## Core Bus Corridor 11: Kimmage to City Centre

17th April 2020

Figure 3 - Harold's Cross Road (looking North)

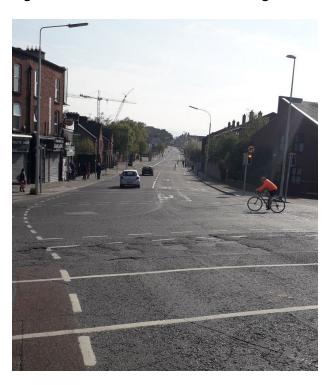
As per the plans, the approximately 400m long stretch of road from Harold's Cross Park to Harold's Cross Bridge will essentially become a wide, tree-less and barren corridor - even more so than at present - and is likely to attract high motor vehicle speeds given the clear sight-lines both from near the park or near the hospice entrance looking north (Figure 3) and from Harold's Cross bridge looking south (Figure 4). This stretch of road is currently grim and noisy, which is especially palpable if sitting outside the HX46 café on Harold's Cross Road. What this stretch of road needs, more than anything, is some type of carefully considered arboreal intervention to radically change the atmosphere of the road - it is screaming out for trees! For most of this road there are houses, apartments or offices adjacent to the road, as well as (crucially!) the primary school close to the park. This particular stretch of road needs a rethink so that it does not end up feeling like a 1960s style treeless urban highway (albeit one with a bus and cycle-lane in either direction).
